ADDENDUM

ADDENDUM No. <b>2</b>		GMCa JOB #: 202113 TDH
ISSUE DATE: 04.05.24		SBC #: 364/011-05-2021
PROJECT: Tennessee Tech University Derryberry Hall – Building Upgrades – Phase I		1 William L. Jones Drive Cookeville, TN 38505
OWNER: Tennessee Tech University		1 Bridgestone Park, 3 <sup>rd</sup> Floor Nashville, TN 37214
ARCHITECT: Gilbert McLaughlin Casella architects		2305 Kline Ave, Suite 200 Nashville, TN 37211

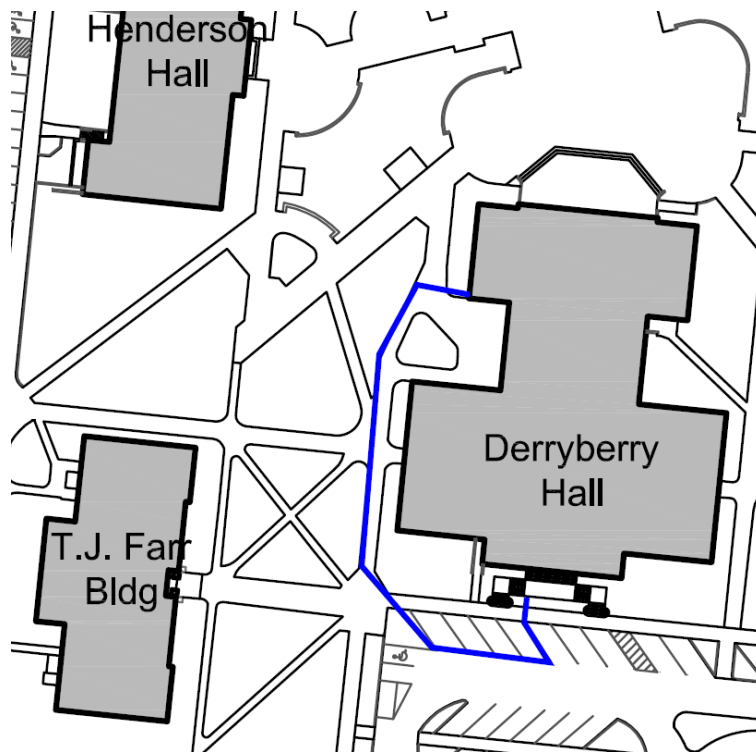
- c) *Question:* Do you have a sketch of the approved fence and staging/parking area that we can share with fencing subcontractors for pricing?

**Response:** Below is a very general site plan depicting a conceptual construction staging/parking zone that can be fenced (represented in “blue”). Please note that the west side of the double front entry stairs will need to be closed off in this scenario. The exact configuration may be adjusted slightly to accommodate the contractors anticipated needs, as long as these adjustments are coordinated with TTU.

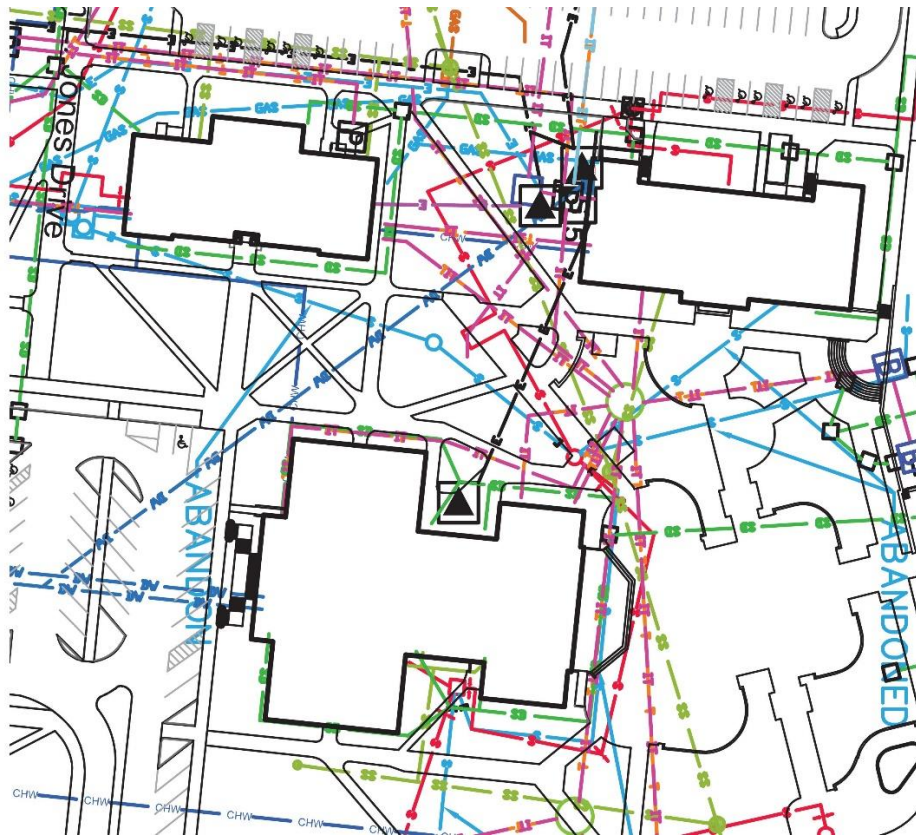
- e) Question: Are there any shallow underground lines on the west side of the building that could potentially be damaged by equipment during construction activities?

Response: Below is a low-resolution snapshot representing the general locations and types of underground lines. This may not include all the actual underground conditions. The depths of these items are unknown. TTU will provide the contractor with a higher resolution document when construction commences to help assist in avoiding any potential site conflicts.

INTERIOR FINISH LISTING AND NOTES

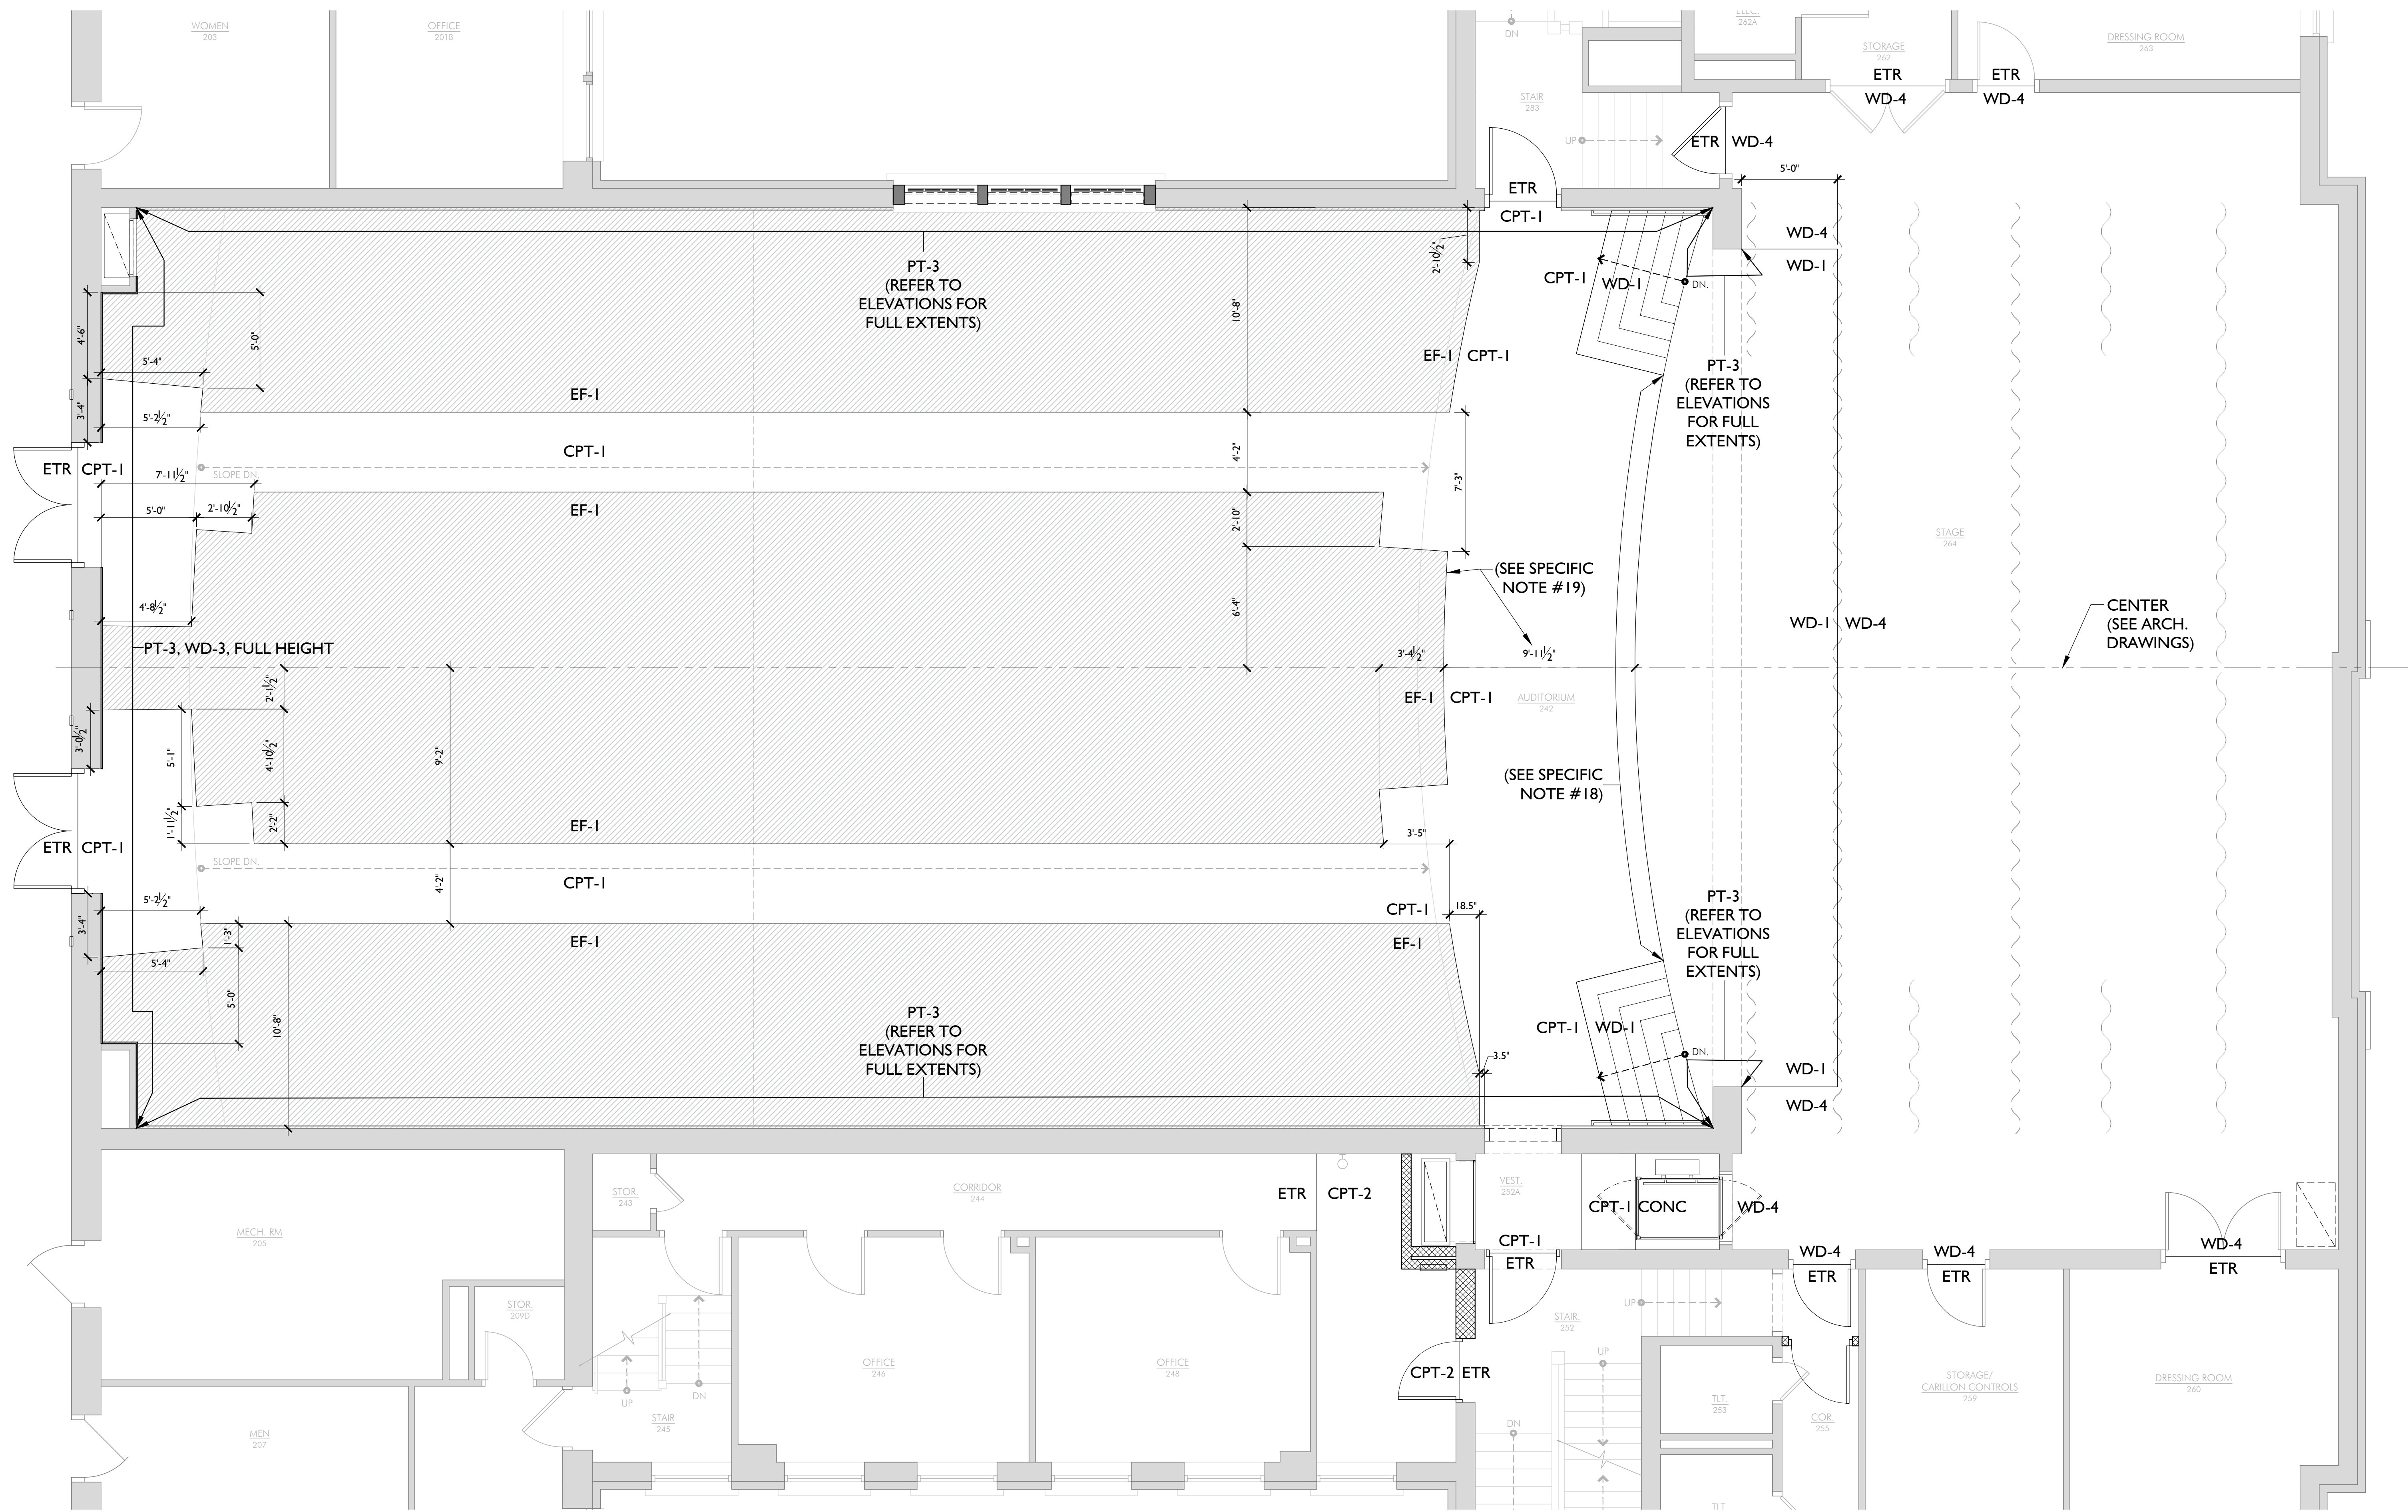
2. ID1.0 – Interior Finish Listing and Notes
  - a. Specific Finish Note #7: Clarification note added.
  - b. Interior Finish Legend: The last three digits of CPT-1 Strikeoff # changed from “100” to “110”

- c. Interior Finish Legend: PL-1 contact, product, and finish information updated.
3. ID1.1 – Interior Finish Plan and Schedule-Level 1 & Level 2
  - a. Specific Finish Note #7: Clarification note added.

INTERIOR FINISH PLAN AND SCHEDULE - LEVEL 3 & LEVEL 4

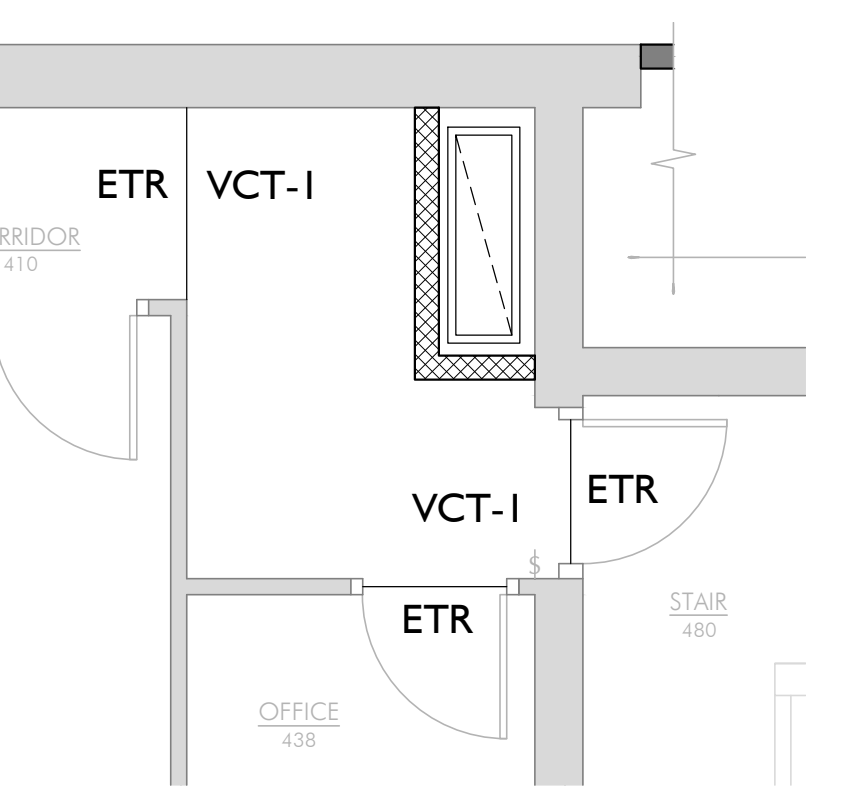
4. ID1.2 – Interior Finish Plan and Schedule-Level 3 & Level 4
  - a. Specific Finish Note #7: Clarification note added.
